Aquia Dam. Inventory Number: VA-17911.
Potomac River Basin. Stafford County, Virginia.
Phase I Inspection Report.

AQUIA DAM - LAKE SMITH IMPOUNDMENT
STAFFORD COUNTY, VIRGINIA
INVENTORY NO. VA 17911

Name of Dam : Aquia Dam, Lake Smith Impoundment
State : Virginia
County : Stafford
Stream : Aquia Creek
Date of Inspection : December 4, 1978

PHOTOGRAPH NO. 2
Principal Spillway Outlet Pipe
& Erosion under Emergency Spillway

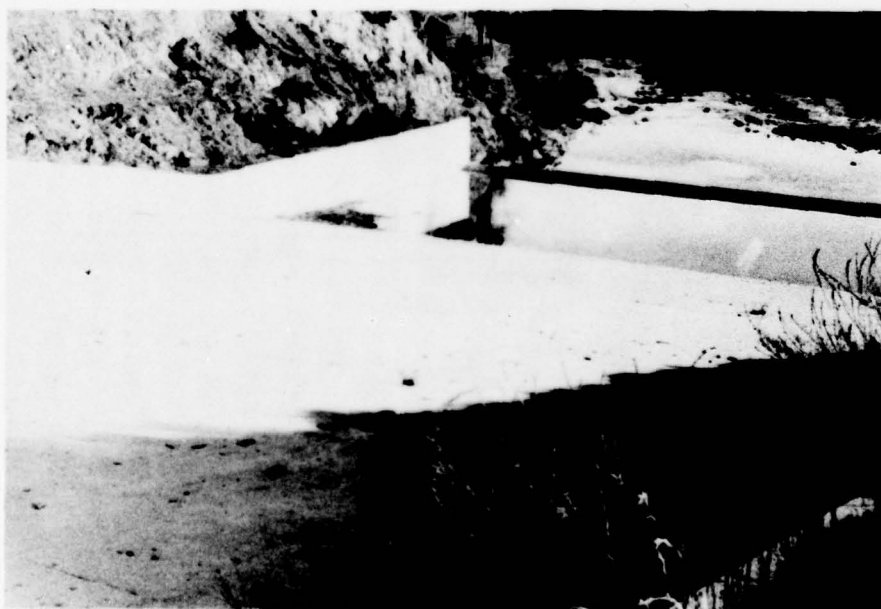
The 60-inch diameter principal spillway outlet pipe is located in such a position that together with the lack of sufficient riprap, the discharge erodes under the emergency spillway structure. The outlet area needs protection against discharge erosion by an addition of riprap.

7.1.4 There is insufficient riprap in the area around the end of the principal spillway pipe and the velocity of the discharge water is sufficient to cause erosion under the emergency spillway structure. Riprap must be installed and the erosion repaired.

7.2 Remedial Measures/Recommendations: The spillway capacity must be increased to pass the PMF and geotechnical data obtained to establish the design and stability of the embankment. The riprap at the discharge pipe must be installed, erosion under the emergency spillway repaired, and rock debris in the downstream channel cleared.
